FINAL DRAINAGE LETTER FOR CALM BREEZE FILING NO. 1 EL PASO COUNTY, COLORADO

Please include:
PCD File No. SF2614

Project #08-101

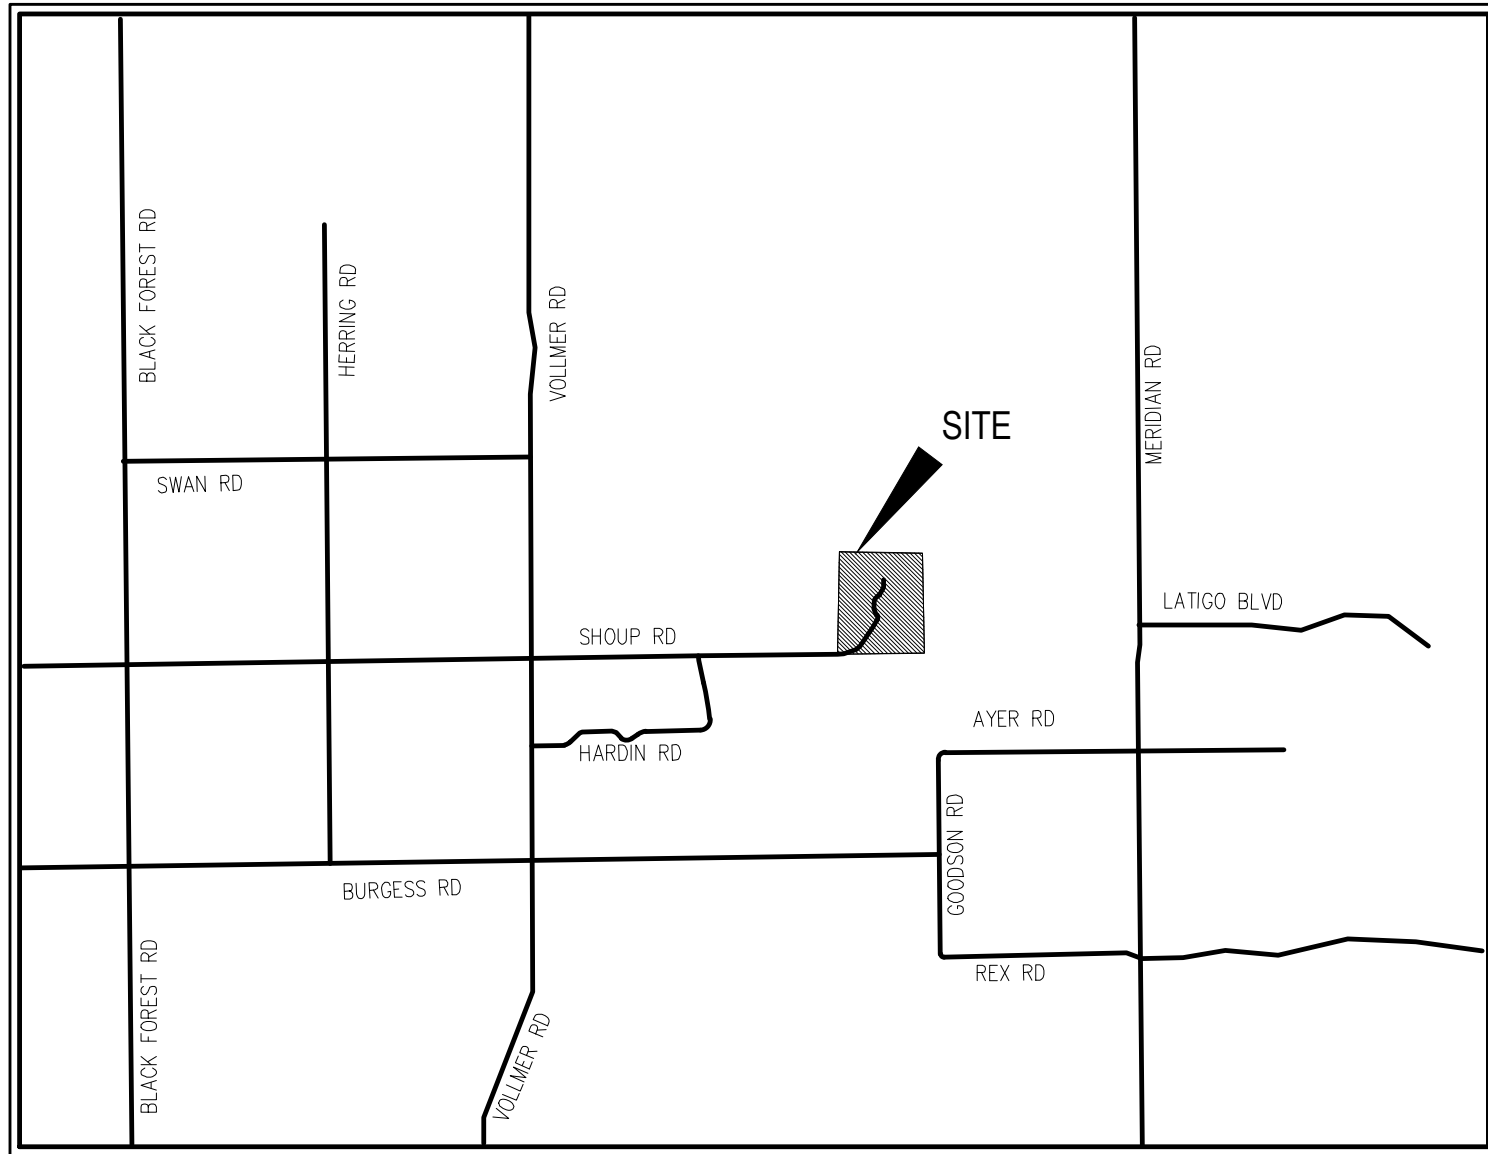
Once the proposed homes, driveways, etc. are included in the report, please provide a comparison of existing vs. proposed runoff for the 5 and 100 year events.

EXISTING DRAINAGE MAP

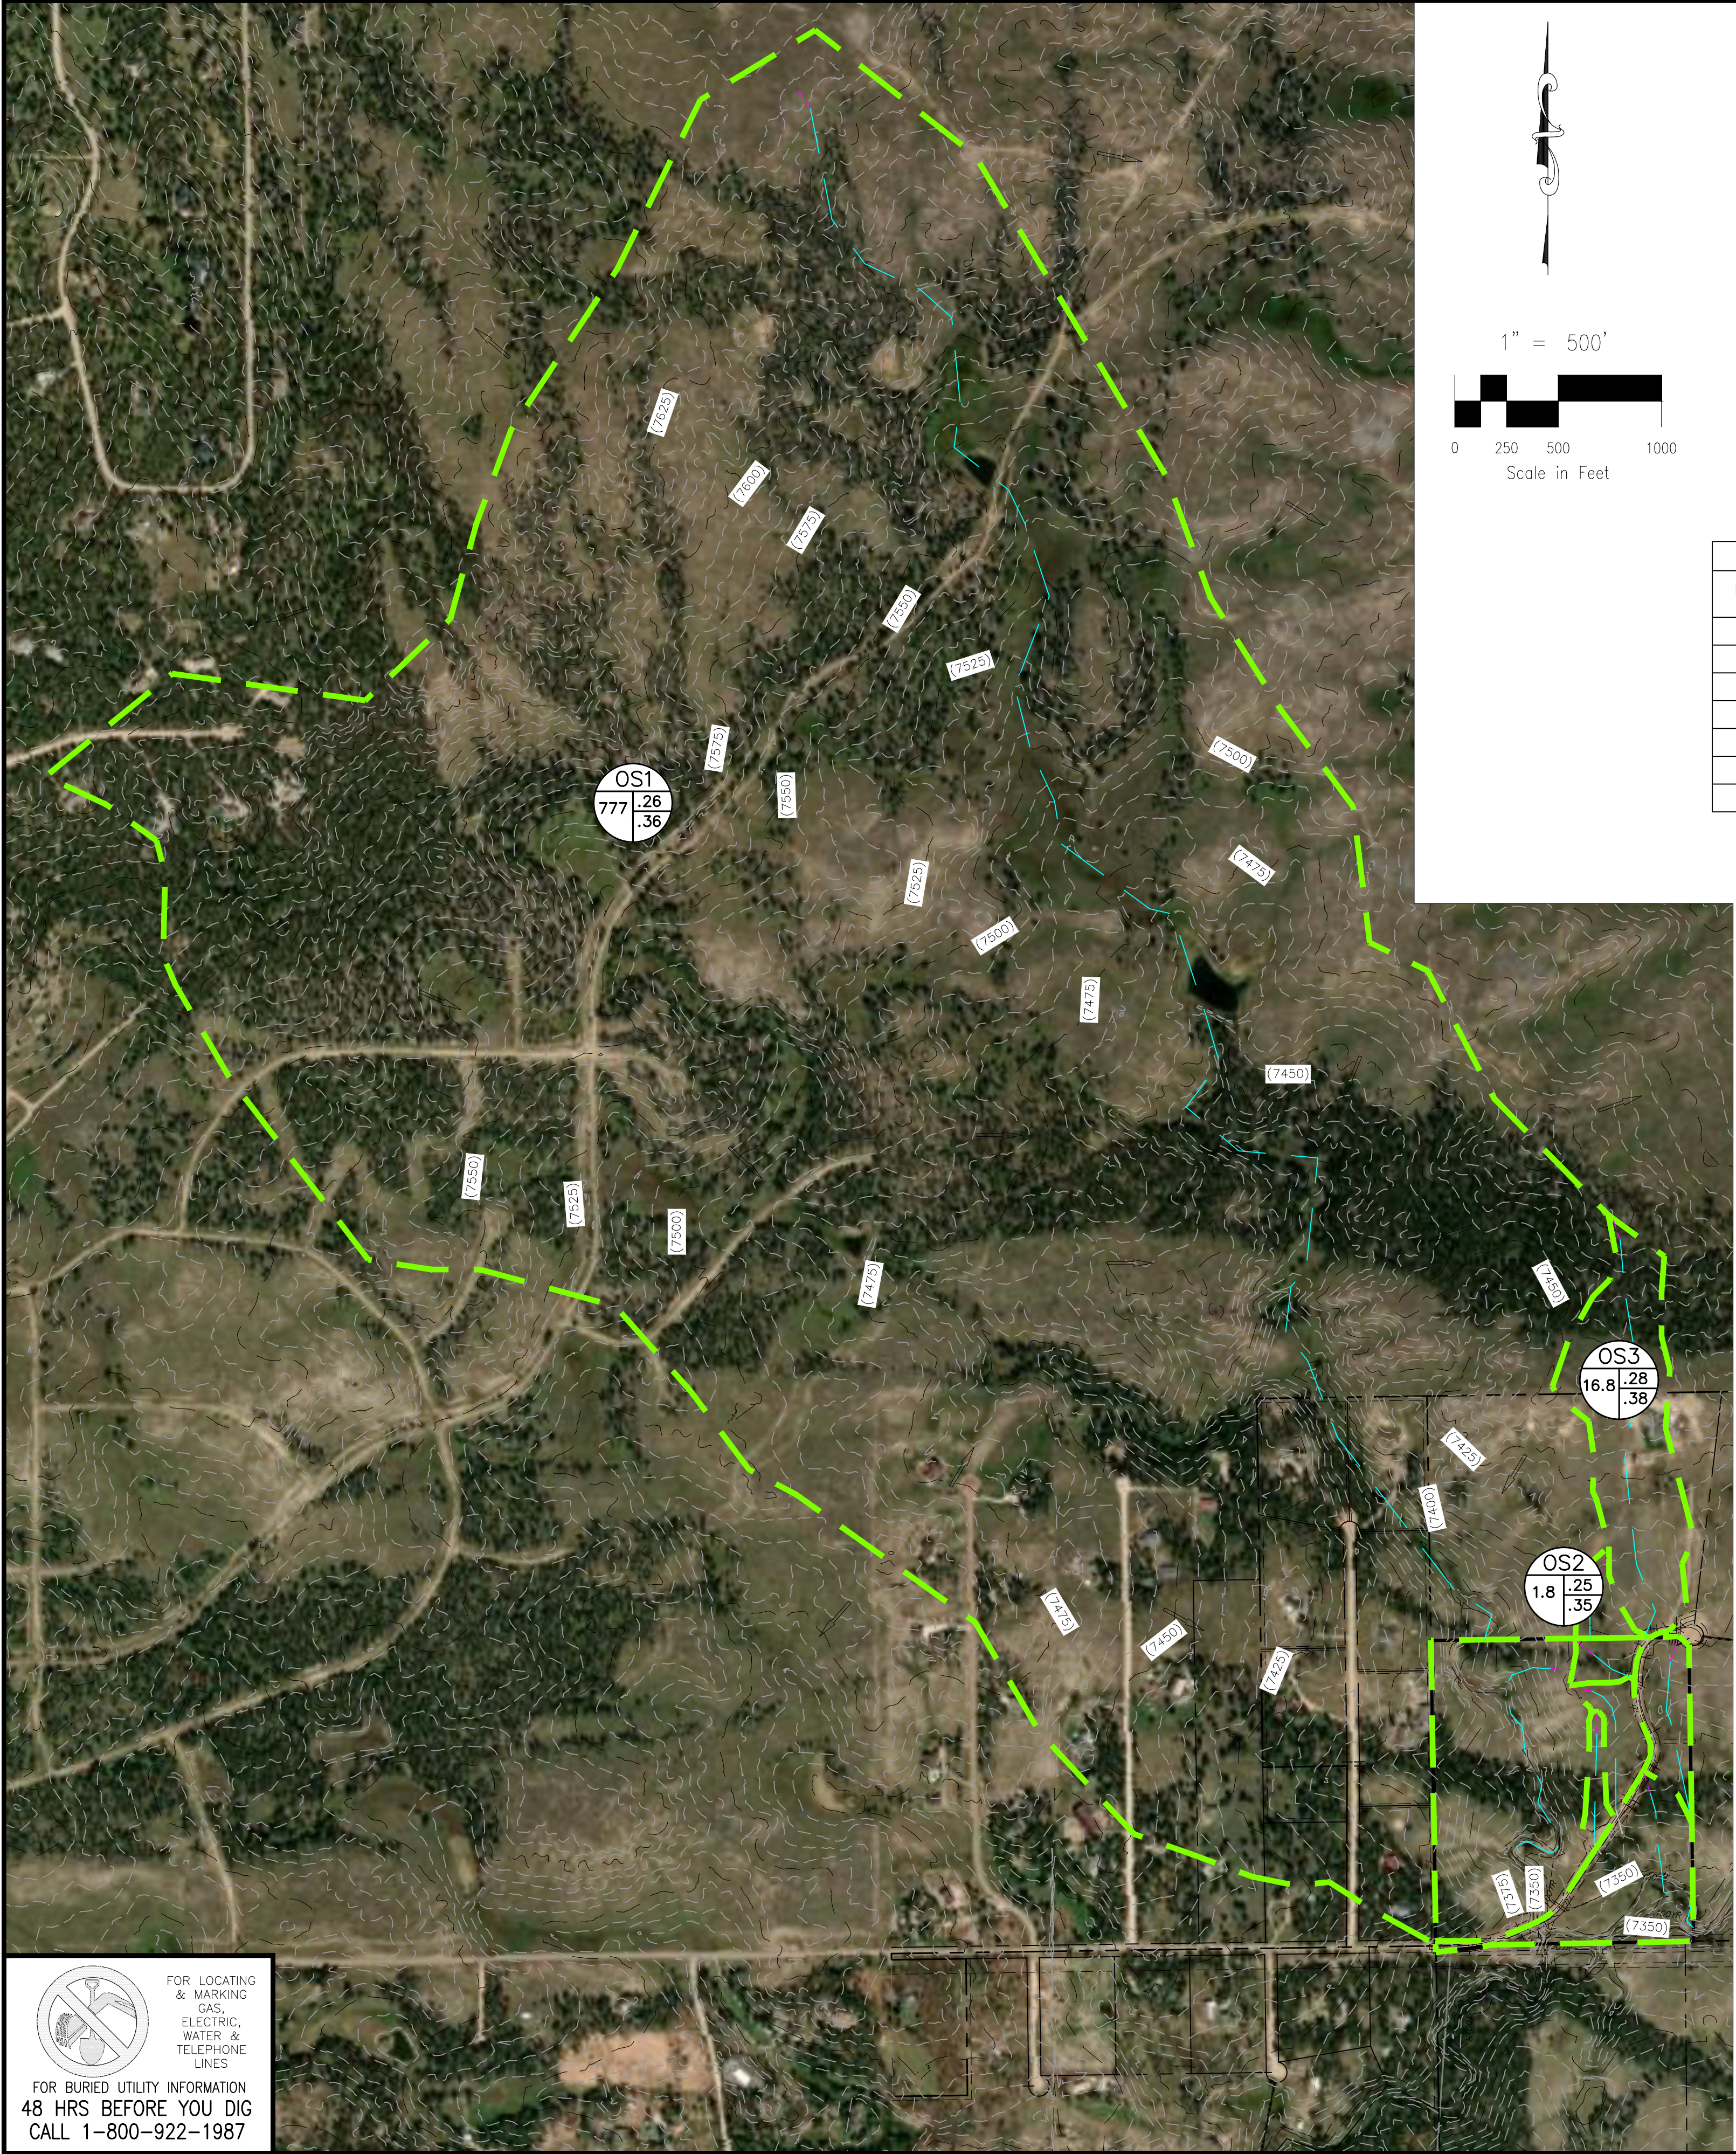
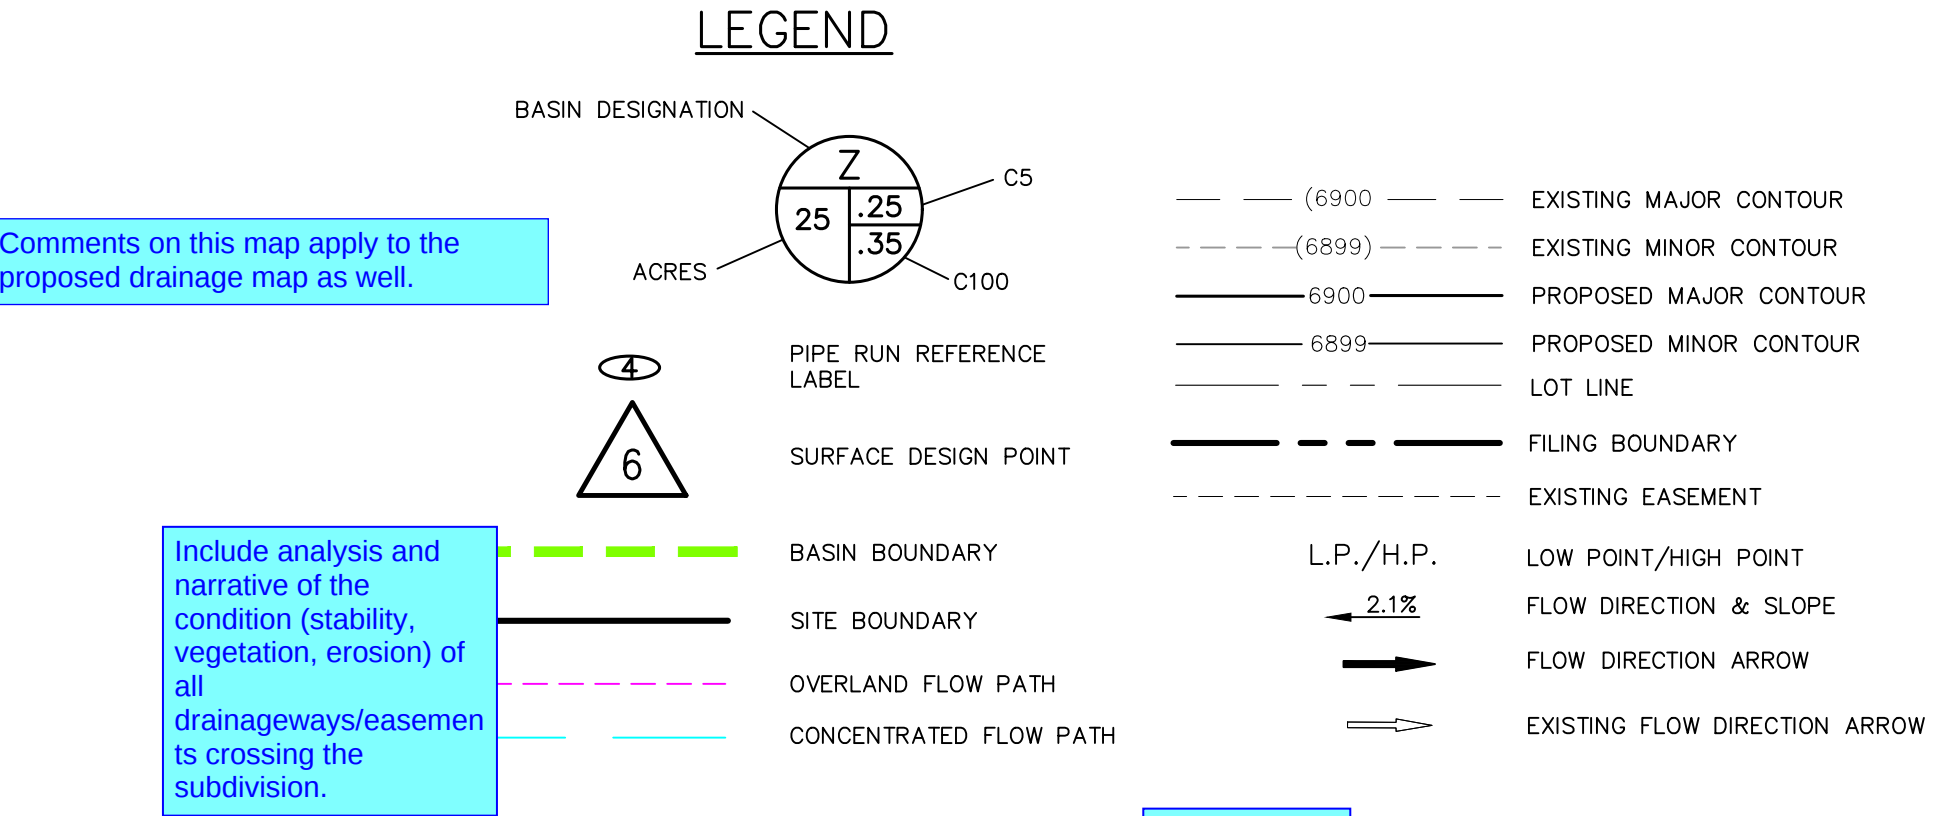
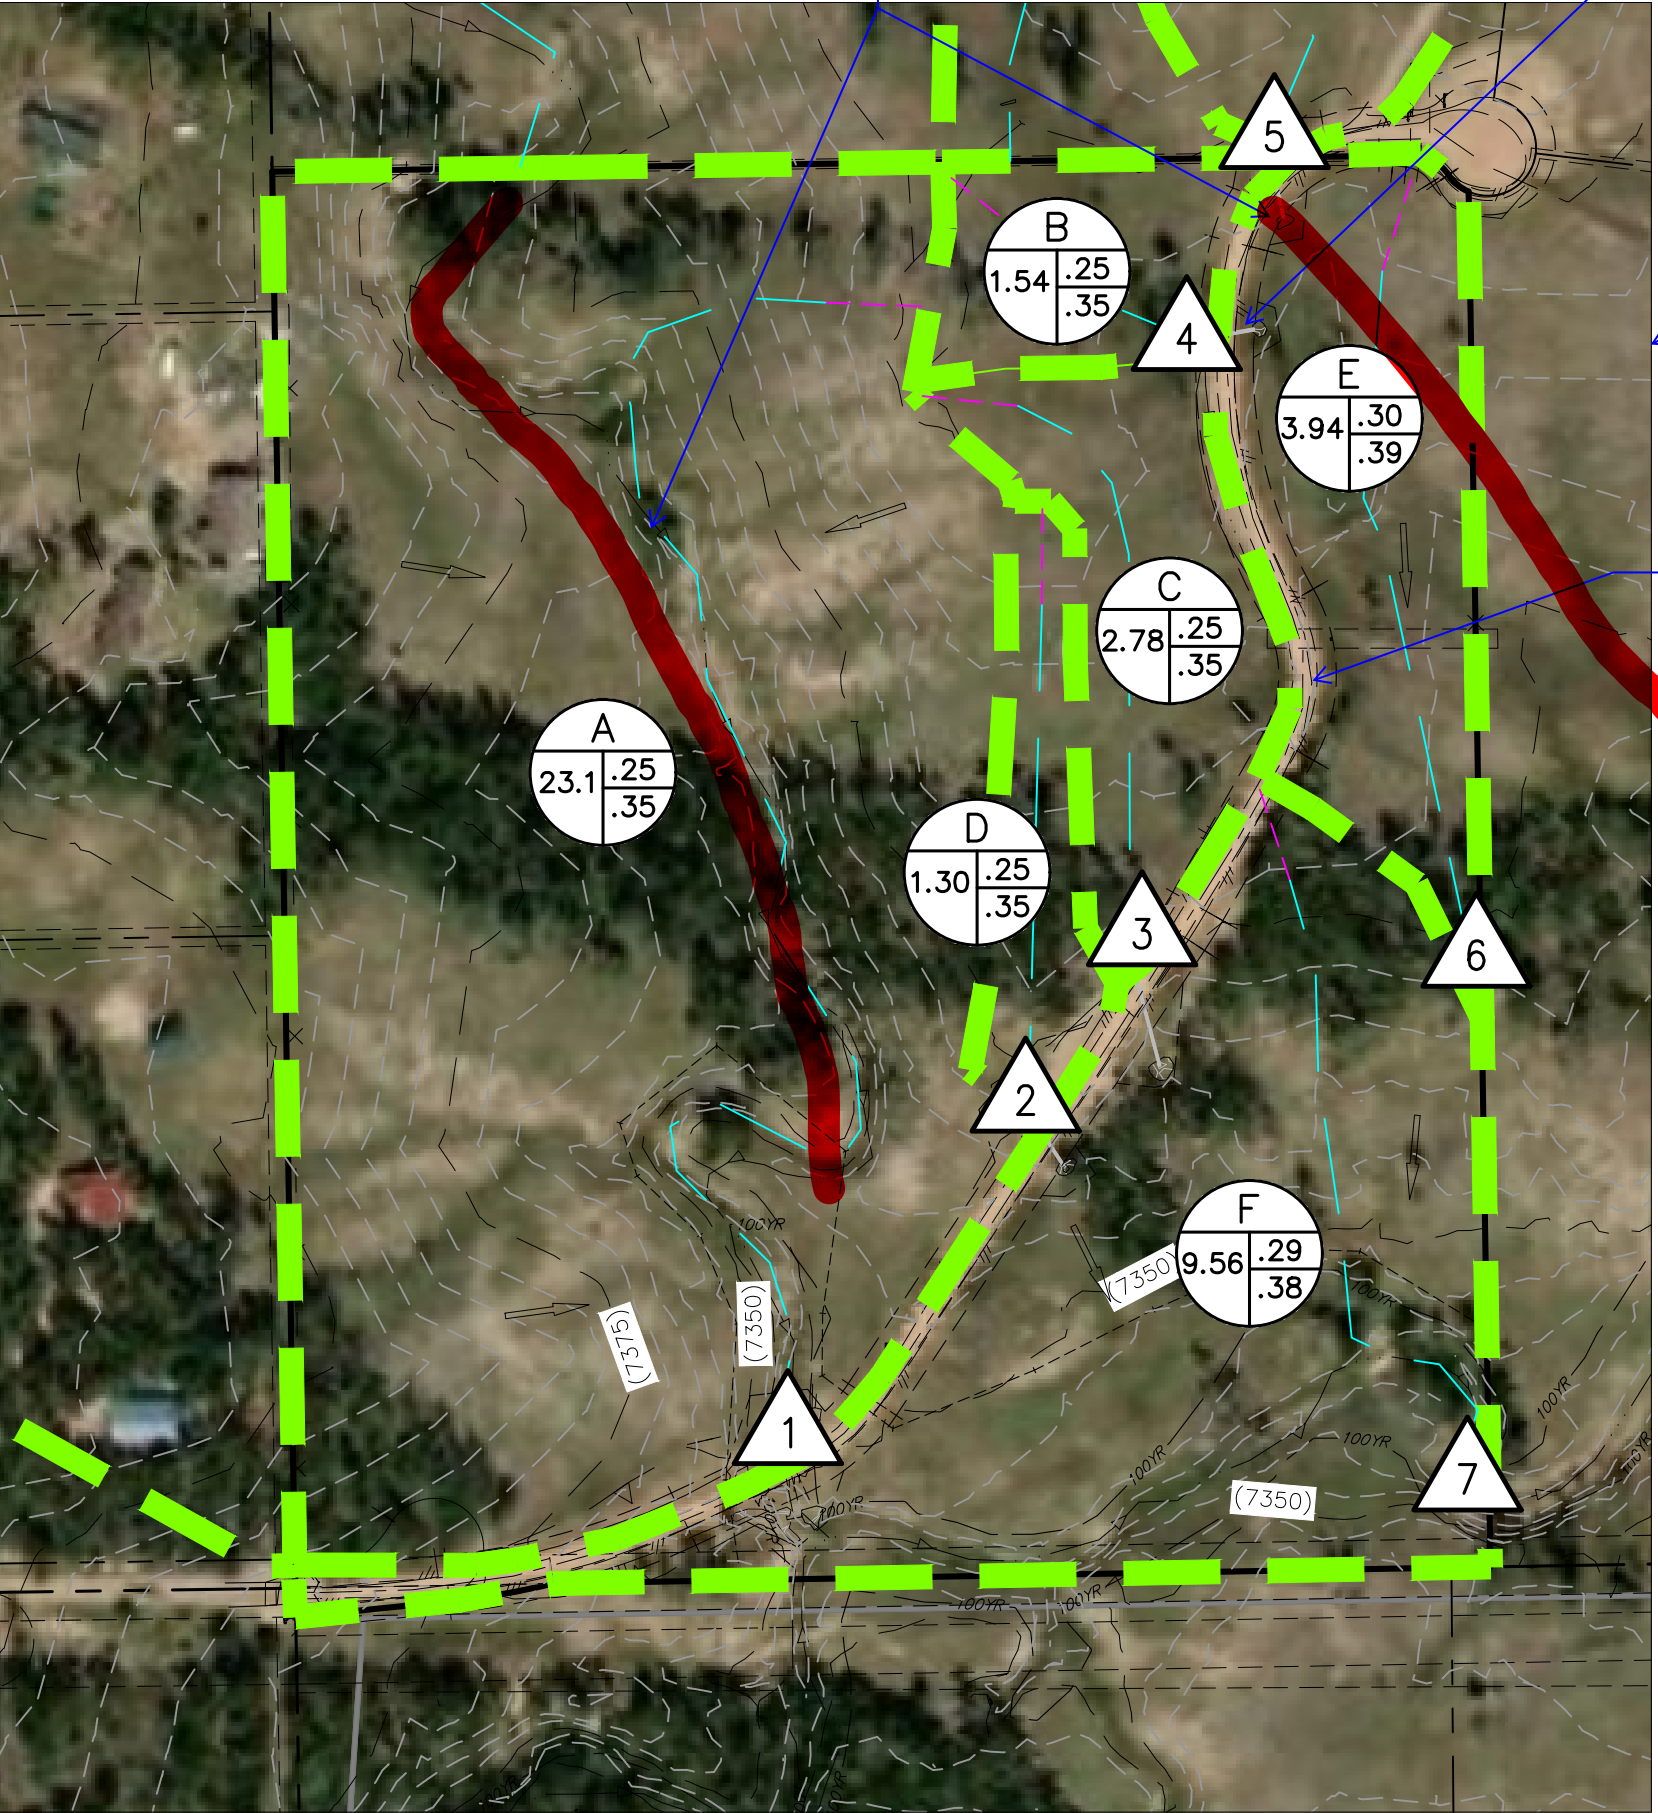
Please label pipes / box culvert on drainage maps.

Comments on this map apply to the proposed drainage map as well.

Label pipe types and sizes

Please provide 2 foot contours as the 5 foot contours do not provide enough detail.

Contours are not accounting for the existing road. Please revise.

This is the maximum scale allowed in DCM chapter 4 and does not provide enough detail for this ~40 acre subdivision. Please revise scale.
